Subject: Duke Energy Carolinas, LLC (Duke Energy)  
McGuire Nuclear Station, Units 1 and 2  
Docket Nos. 50-369 and 50-370  
Relief Request Serial # 11-MN-001, Response to Request for Additional  
Information on Limited Weld Examinations for Refueling Outages 1EOC20 and  
2EOC19

Relief Request 11-MN-001 Request for Additional information (RAI)

1EOC-20 and 2EOC-19 Limited Weld Exam Third interval 10 Year ISI

WELD LOCATION  
SECTION #4 TO  
RAI 11-MN-001

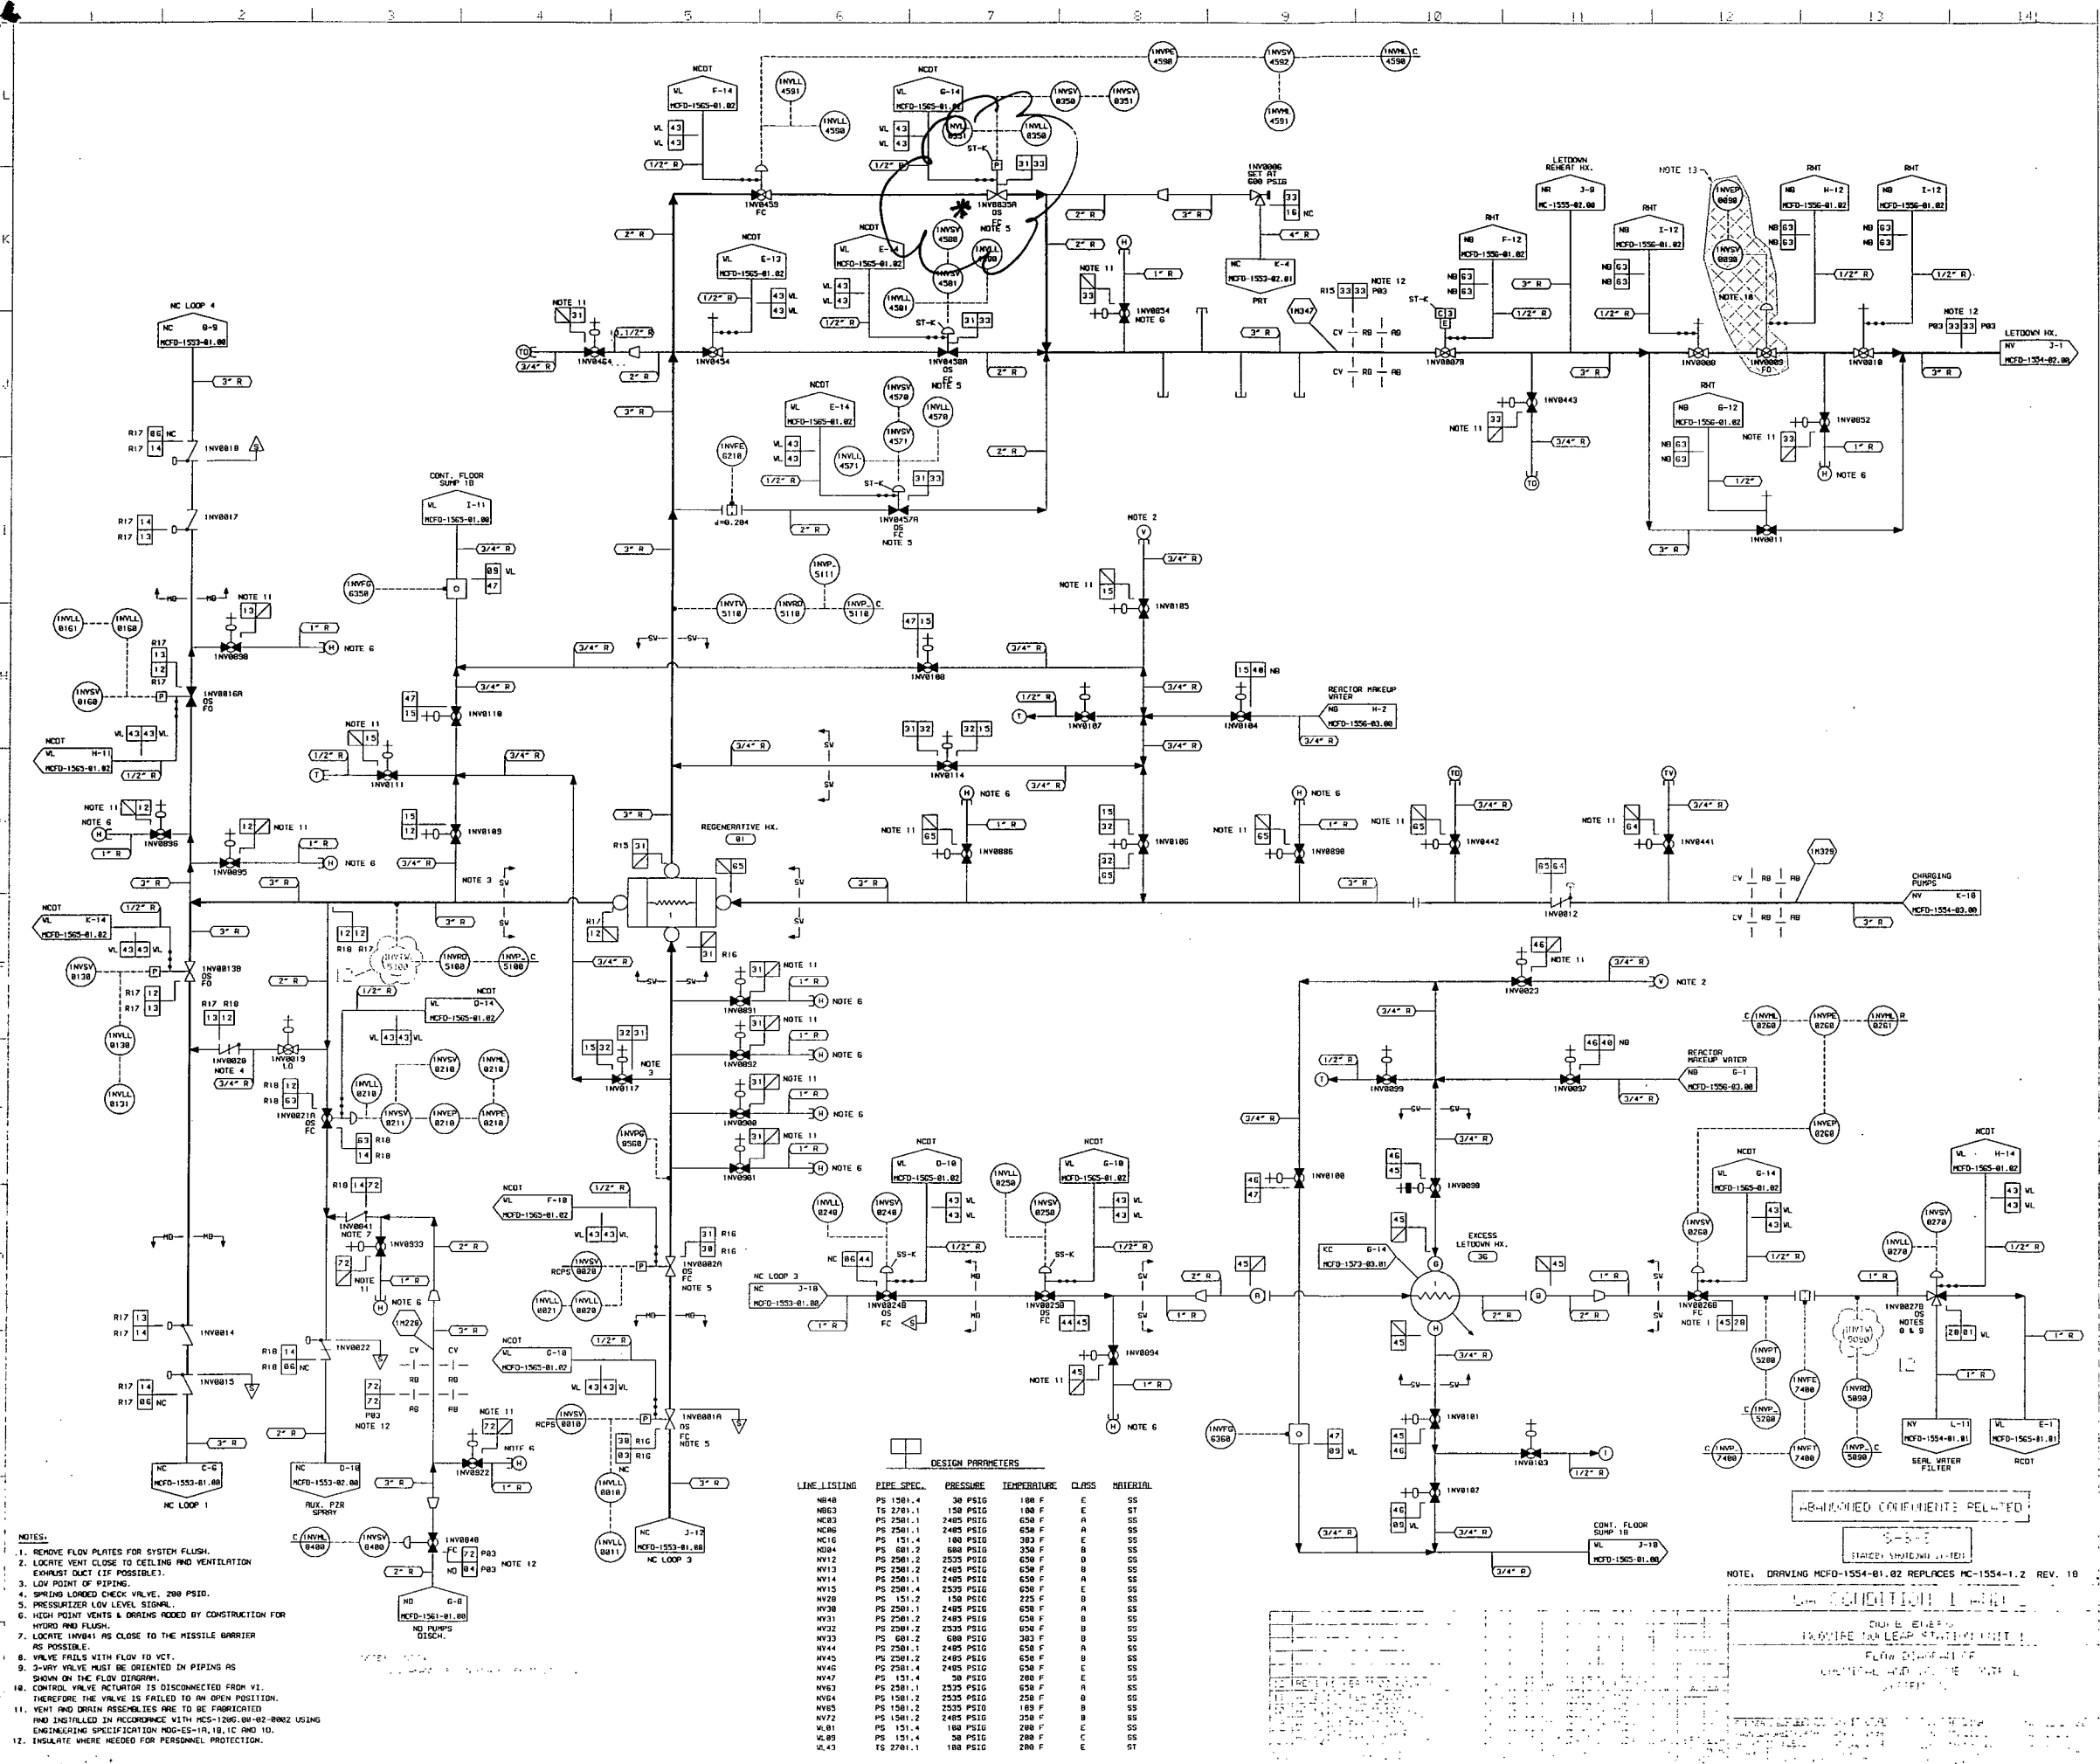
*For sections 2, 4, 10, 11, 12, 13, 14, 15, 16, and 17: To determine the level of safety significance for each weld, NRC staff needs to know which system would be impacted by a leak or failure of the weld or welded attachment in question. This information is provided in the enclosures for some, but not all welds. To assist the NRC staff in assessing each weld, please provide a table for all welds in RR sections 2, 4, 10, 11, 12, 13, 14, 15, 16, and 17 that describes the locations of each weld and the systems to which each weld belongs.*

*For sections 2, 4, 10, 11, 12, 13, 14, 15, 16, and 17 the components are described as being made of stainless steel. For each weld, please specify which components, if any, are made of cast stainless steel.*

Duke Energy Response: The one weld associated with these sections that connects to a component fabricated from cast stainless steel is listed in Section #4 (weld #1NV1FW53-27). The specific component fabricated from cast stainless steel material (ASME SA 351 Grade CF8M) is valve 1NV-35A.

McGuire Flow Diagram MCFD-1554-01.02 rev 11 with weld location identified for Section 4 weld #1NV1FW53-27:

\* UNIT 1 - NV1FW-53-27
